August 12, 2016

RE: Glade Creek II Restoration Project Baseline Monitoring Report
Draft Report Comment Response/Final Report Submittal for DMS
DMS Project #92343
New River Basin – CU# 05050001; Allegheny County, NC

GLADE CREEK II RESTORATION PROJECT

Alleghany County, NC
SCO Project ID 07-07088-01
DMS Project Number 92343
DWR Number 09-0049
USACE Action ID 2009-00589

Figure 1 Project Vicinity Map
 Glade Creek II Restoration Project
 DMS Project No. 92343
 Monitoring Year 0 - 2016

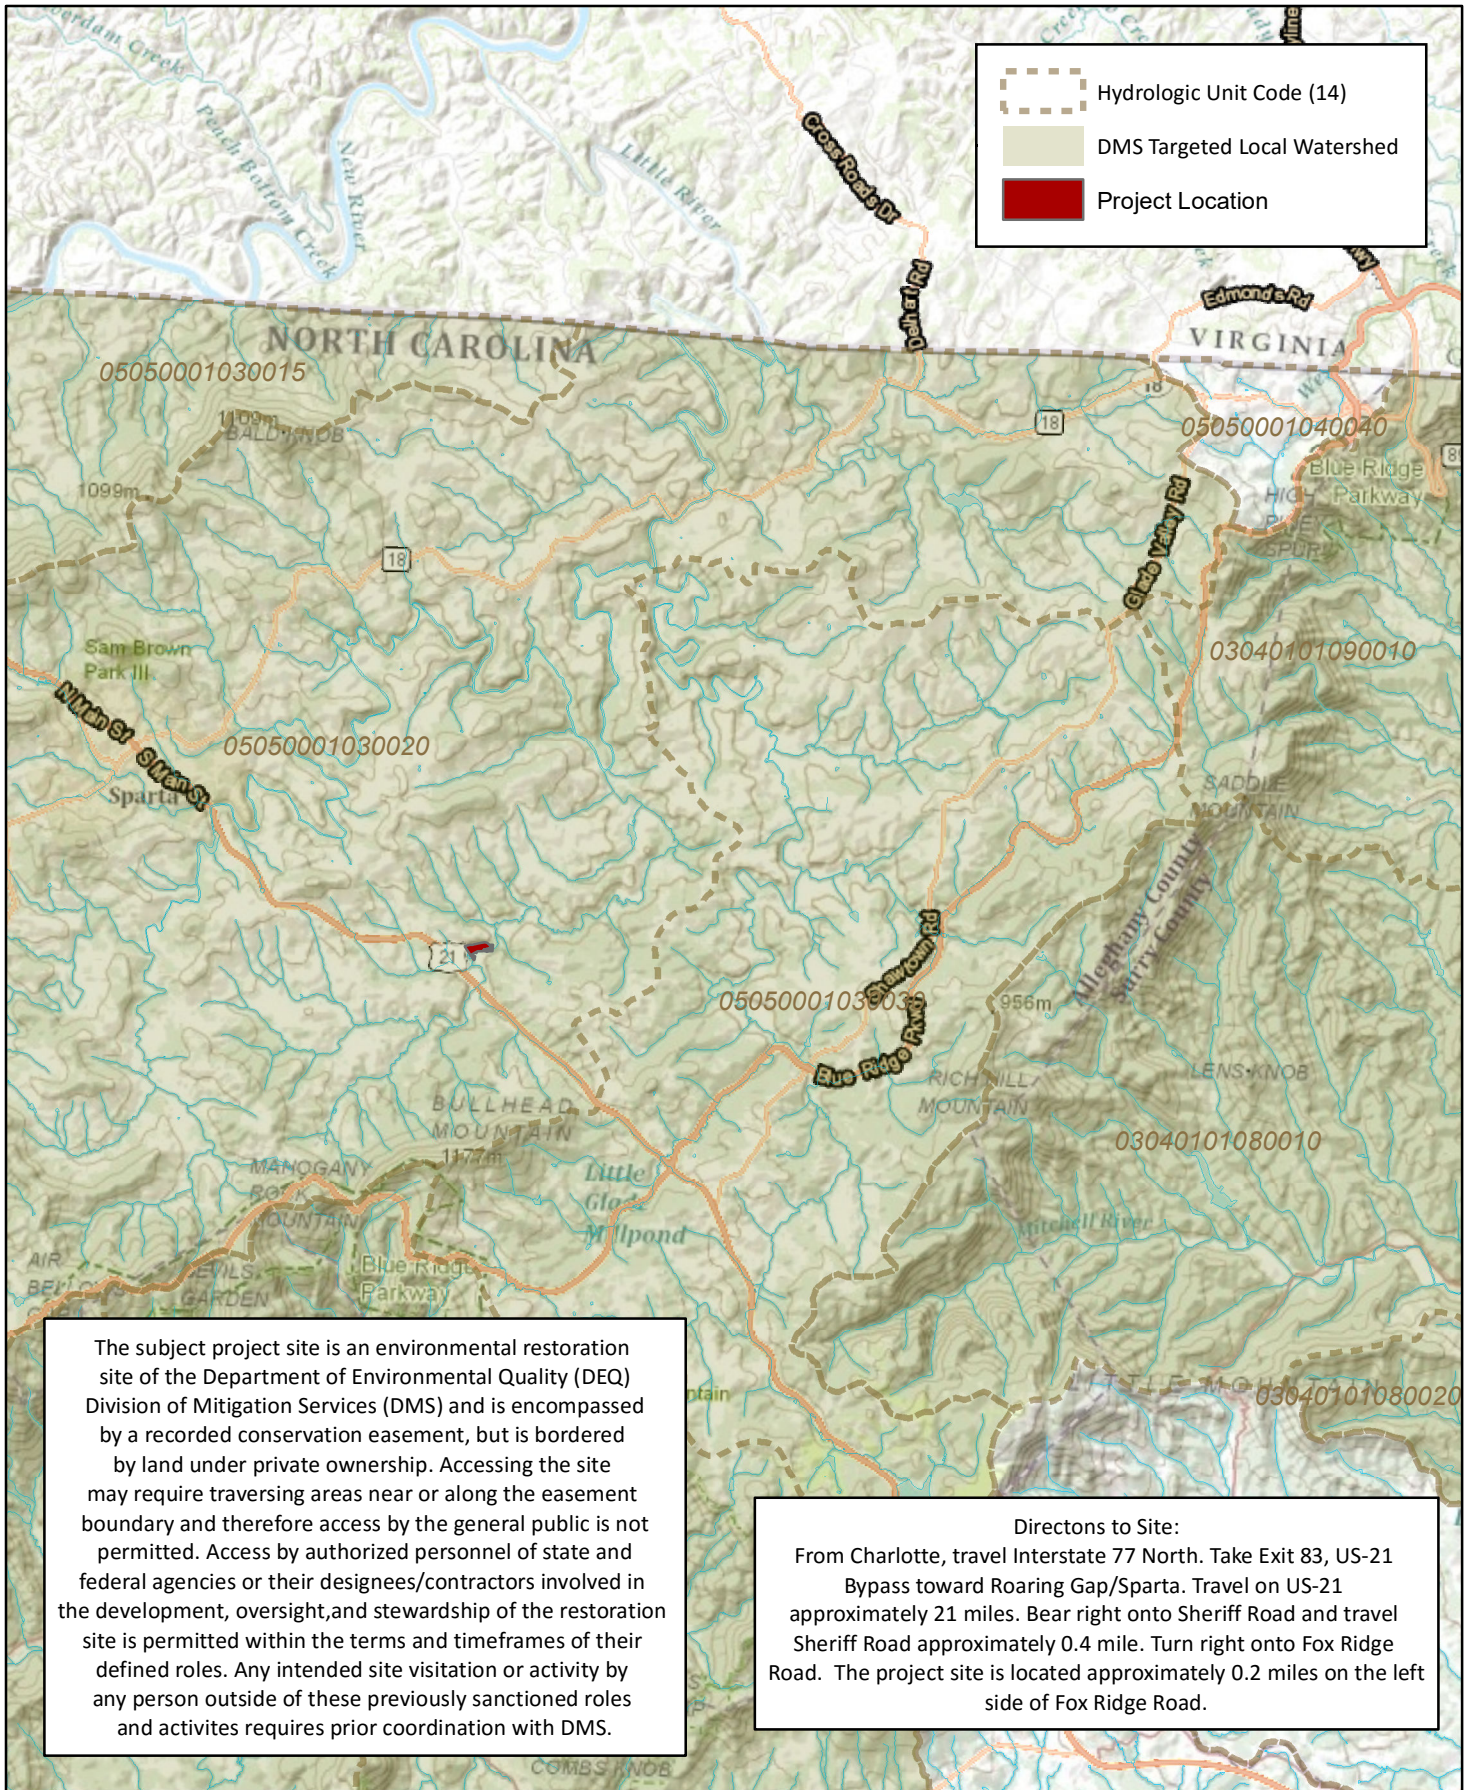
6. Figure 1 – project location should be outline of the easement, not shaded in red; make roadways and text features more prominent.

Wildlands Response: Figure 1 has been updated.
